Planning Appeal Reference: APP/W0530/W/18/3210008

Planning Application Reference: S/4099/17/OL

1. I am writing as a resident of Hinxton in opposition to the proposed Smithson Hill scheme (reference above).
2. Further to my original representation dated 26th January 2018 to the planning application, I would like to re-submit my comments relating to the uncommercial parking ratios proposed and provide some further anecdotal traffic data. There are many other issues with the application (environmental aspects and the fact that such a large scheme should be assessed through a local plan process), but I would particularly like to speak at the Inquiry in relation to my concerns over the unrealistic parking ratios and the reality of existing highway capacity.

16/1/19 – 08.12 – cars queuing back beyond Hinxton Grange gates – over 100 cars

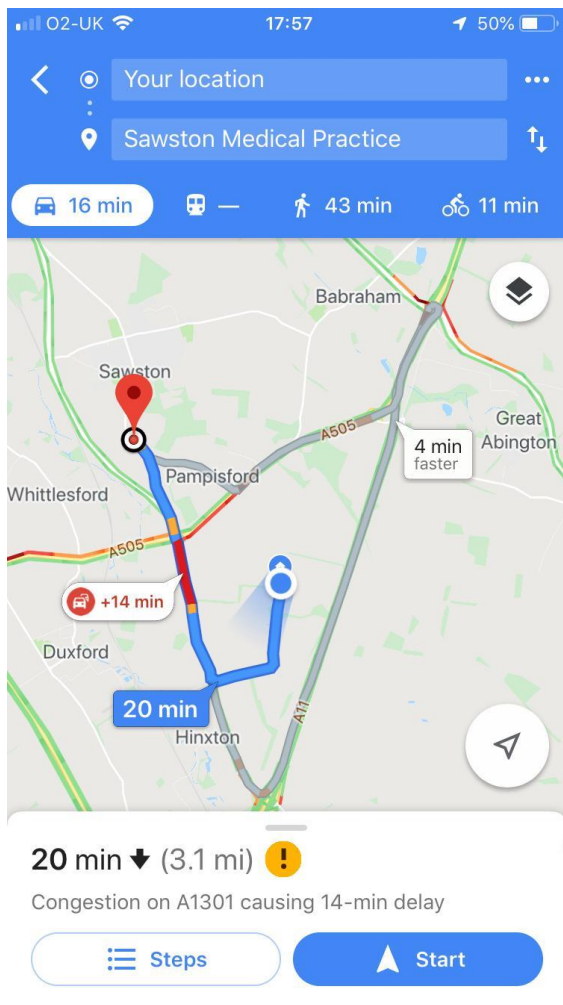
10. The photos below illustrate the queues all year round, morning and evening:

1. Googlemaps Route to Sawston Medical Practice – 17.57, Monday 28th January 2019.

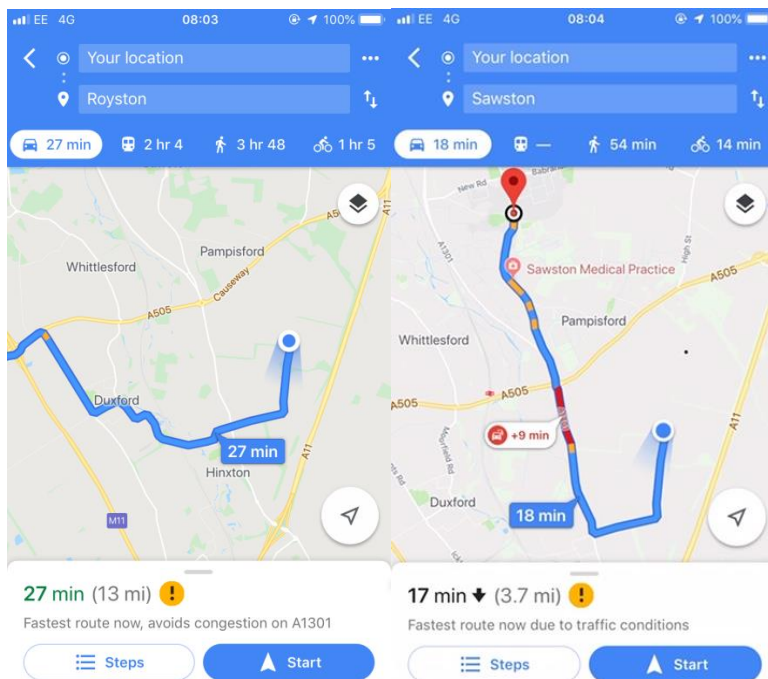
1. There is a 14 minute wait to get the roundabout (and queueing times are invariably underestimated by googlemaps).
2. The recommended route is to go south away from Sawston, past the Genome campus, up the A11, around the A1307 roundabout, back onto the A505 and then to cut through the village of Pampisford to avoid the congested McDonalds roundabout. This would save 4 minutes (assuming the queue time is correct).
3. The route is 9 miles - 3 times further than the most direct route via the A1301 McDonalds roundabout.

1. Massive congestion at the A1301/A505 roundabout causing major disruption to our lives.
2. Rat-running through the villages – in this case Pampisford. This issue has been made worse but the now almost universal use of satnavs or apps like Googlemaps or Waze.
3. There is a significant environmental impact of having to drive 3 times as far to try to beat the queues.

2. Googlemaps Route to Royston – 08:03, Monday 4th March 2019.

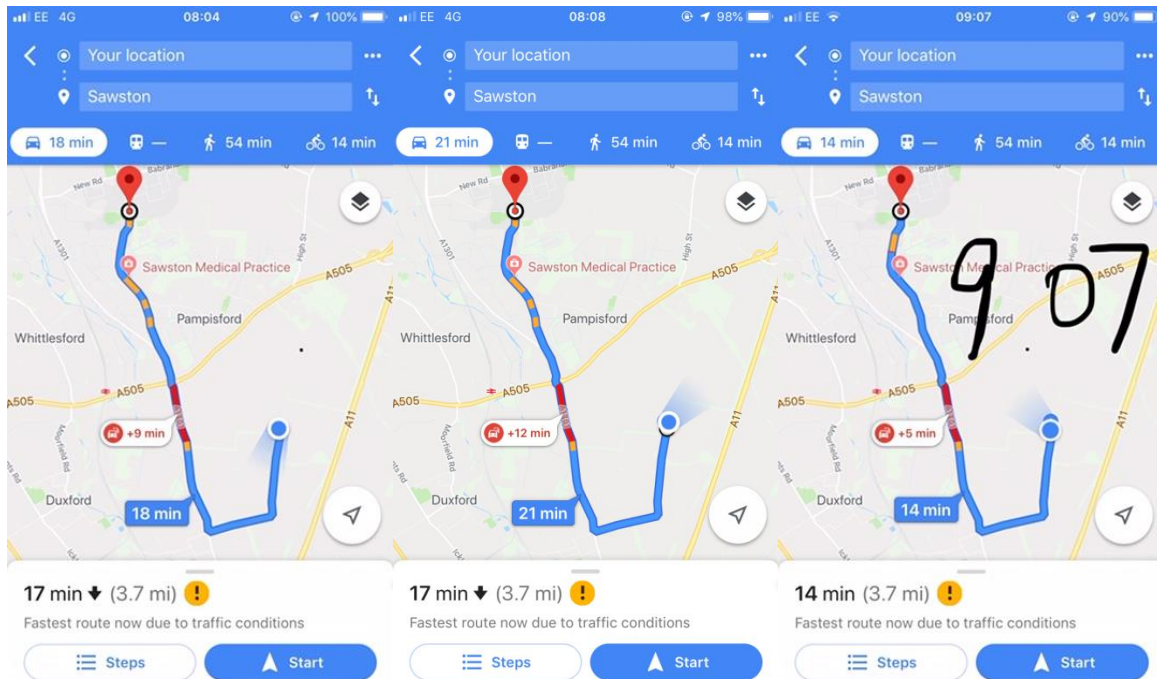
1. To try to demonstrate the issues, I checked googlemaps on the morning of writing this representation (4th February 2019), and at 8.03am there was a forecast 9 minute queue to the A1301/A505 McDonalds roundabout (right hand image).
2. To make a trip west on the A505 (e.g. to Royston), Googlemaps was recommending cutting through Hinxton and Duxford. Note, the comment on the route states “**Fastest route now, avoids congestion on the A1301**”.

This example evidences shows why there is such an issue already with rat-running (at hazardous speeds) through the villages. Such a massive park as proposed by Smithson Hill will cause this to be even worse.
